REF: SPR-47-24

Request - Appeal of Administrative Disapproval of Minor Site

Plan Review for a New Modular Industrial Building

Location - 5715 Angola Road

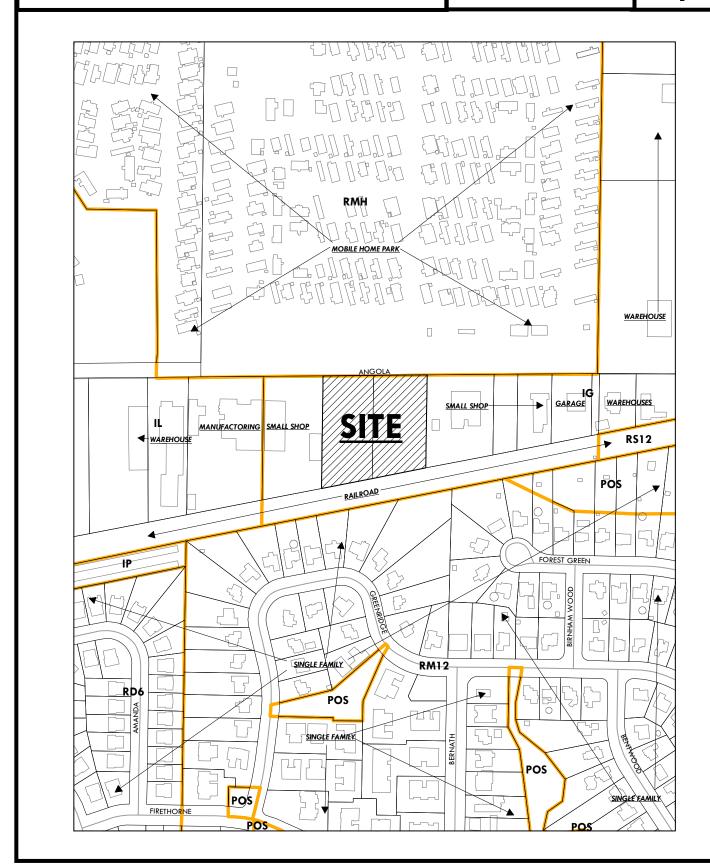
- 17. Subject parcels shall be combined (Parcel numbers: 2611754, 2611774, & 2611771).
- 18. Parking shall adhere to the requirements of TMC§1107.0500 Parking Schedule "C". The parking schedule requires one (1) parking space per vehicle used in business and one per 750 square feet of manufacturing or other floor area (1,312 sq.ft.). **Staff is supportive of the proposed thirteen (13) parking spaces.**

- 19. All spaces reserved for the use by persons with physical disabilities shall adhere to the standards outlined in TMC§1107.1700. Acceptable as depicted with one (1) van accessible space with an eight foot (8') wide aisle shown on site plan.

- 20. Off-street parking and loading spaces, parking lots, maneuvering areas, aisles and driveways must be surfaced with concrete, bituminous asphalt, or other dust-free material other than gravel or loose fill, and be graded to drain all surface water towards the interior of the parking lot (TMC§1107.1906). Not acceptable as depicted. Parking lot shall be in compliance with this section to satisfy the Division of Transportation's comments.

- 21. Bicycle parking slots shall be provided pursuant to Off-Street Parking Schedule "A," (TMC§1107.0300). Minimum number of bicycle parking slots required for a General Industrial use is 1 per 10 parking spaces. Per TMC§1107.0902, bicycle parking is a space at least two feet (2') by six feet (6') per slot. Acceptable as depicted with two (2) bicycle parking slots shown on site plan.

- 22. Whenever a parking lot extends to a property line, sidewalk, planting strip, or building, a wheel stop device consisting of a concrete stop, a permanent concrete curb, an expanded sidewalk or other suitable restraint as approved by the Planning Director must be installed to prevent any part of a parked motor vehicle from extending beyond the property line, overhanging a pedestrian walkway, or sidewalk, or damaging any structure or landscaping TMC 1107.1907(A). Acceptable as depicted.

- a. Per TMC§1108.0202, a fifteen-foot (15') frontage greenbelt is required along Angola Road and shall include at least one (1) tree per every thirty feet (30') of frontage or fraction thereof. Not acceptable as depicted. A total of twelve (12) trees shall be planted. Trees and 15' frontage greenbelt shall be indicated on a revised site plan.

- b. Per TMC§1108.0202, if a parking lot is proposed to be developed in the front of the property, the frontage greenbelt shall include a solid evergreen hedge planting to screen the parking lot so that no headlights of any vehicles can be seen from the public street. Low, undulating (horizontal and vertical) earth berms or decorative stone or brick walls (no concrete block), or ornamental metal fencing or combinations thereof may also be approved by the Planning Director. Not acceptable as depicted. A solid evergreen hedge shall be shown on a revised site plan.

- c. Per TMC§1108.0204, Parking Lot Landscaping must be provided as the IG district abuts a residential use. The total interior landscaping required in parking lots is 20 square feet per parking and stacking space. With thirteen (13) spaces proposed, the site requires 260 square feet of interior landscaping. Not acceptable as depicted. Shall be shown on a revised landscape plan.

- d. Per TMC§1108.0205, one 2-inch caliper tree shall be provided for every 2,000 square feet of building coverage, in addition to landscaping at all main building entrances. Not acceptable as depicted. One additional tree and main entrance plantings shall be shown on a revised landscape plan.

- h. The location, height and materials for any new and existing fencing to be maintained. Outdoor Storage Screening is required for Freight Terminal uses and subject to the requirements of TMC 1108.0203(H). The fence shown on the site plan is not acceptable as depicted as the proposed barbed wire is not permitted per TMC§1105.0303. Applicant shall remove the proposed barbed wire, unless a variance is obtained from the Board of Zoning Appeals.
